ORIGINATION FORM

Proposed Revisions to a Standard Plans Index
(Please provide all information — Incomplete forms will be returned)

Index Number: 425-061
Sheet Number (s): 2
Index Title: Closed Flume Inlet

CLOSED FLUME INLET

INDEX	SHEET
425-061	2 of 5

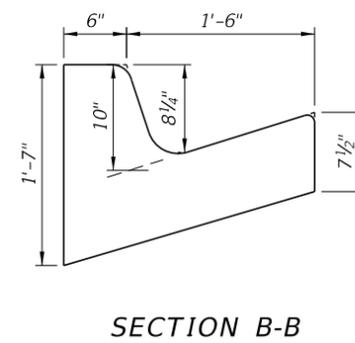
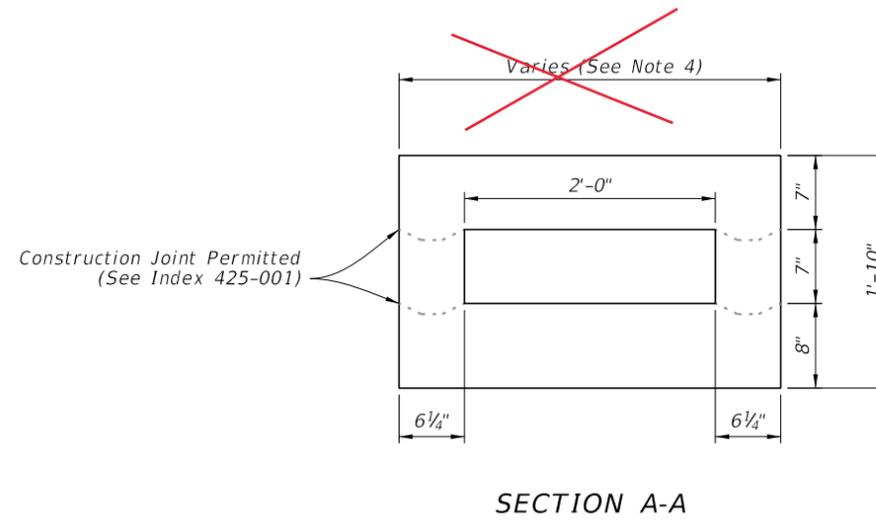
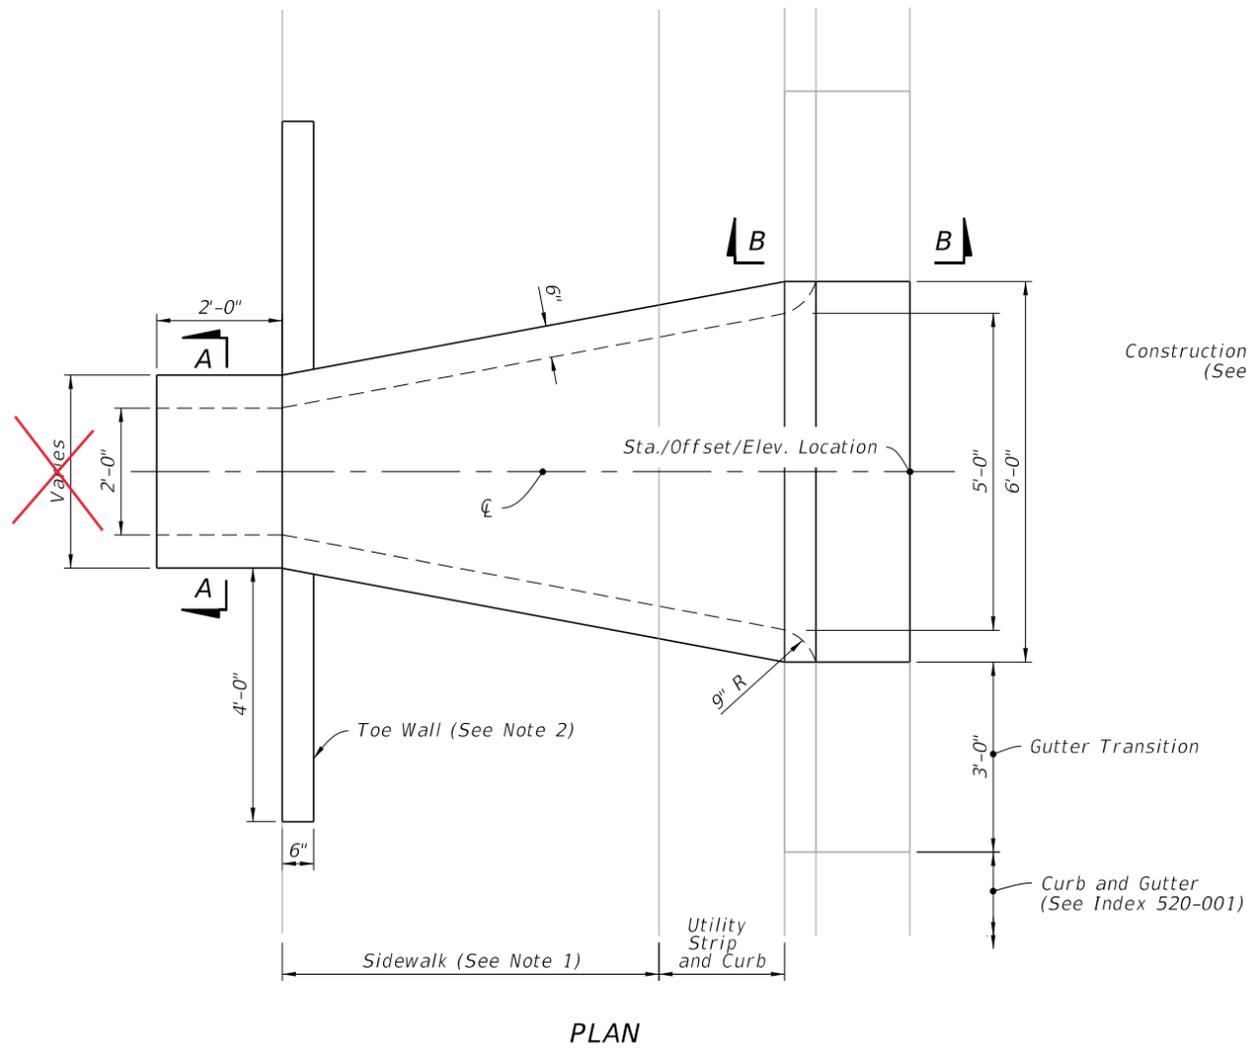
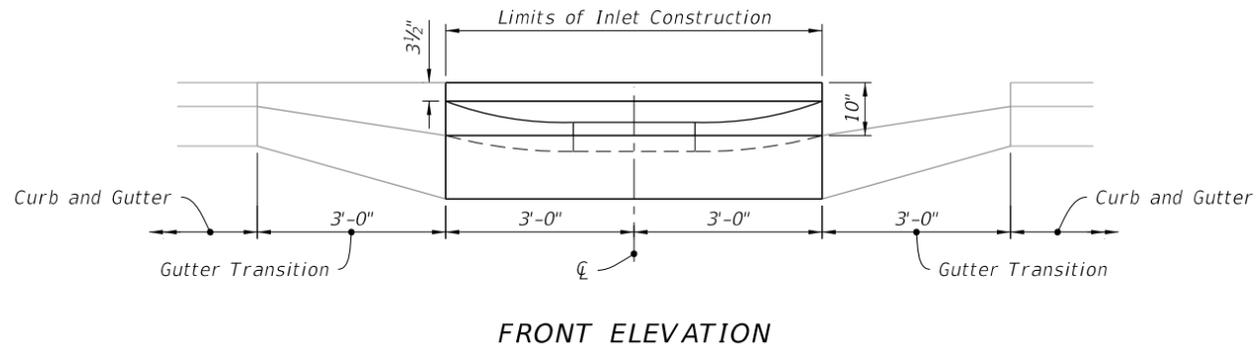
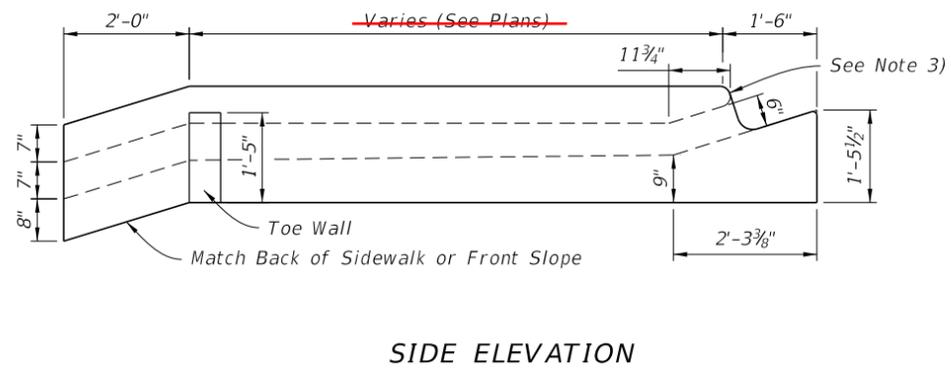
Revised dimension in Side Elevation detail to "Flume Length Varies (See Plans)". This also requires a change to the SPI. Deleted "Varies from 3' 1/2" to 6'-0" for single barrel flume." from note 4. Deleted "varies" from section A-A and Plan view.

Remove reference to Dimension "D" in SPI and change text in SPI and Index to "Flume Length" to allow for this to be called for in the Plans. The "varies" callouts were deleted from the section references and note because the sections as shown are not variable.

- NOTES:**
1. Use sloped section with sidewalk applications only.
 2. Use Toe Walls with Sidewalk application only. For Endwall without Sidewalk see DETAILS on Sheet 4.
 3. Slope to match adjacent curb with 2" top radius and 1 1/4" bottom radius.
 4. ~~Varies from 3'-1/2" to 6'-0" for single barrel flume. See Sheet 5 for multiple barrel flumes span variation.~~

CHANGED TO: Flume Length Varies (See Plans)
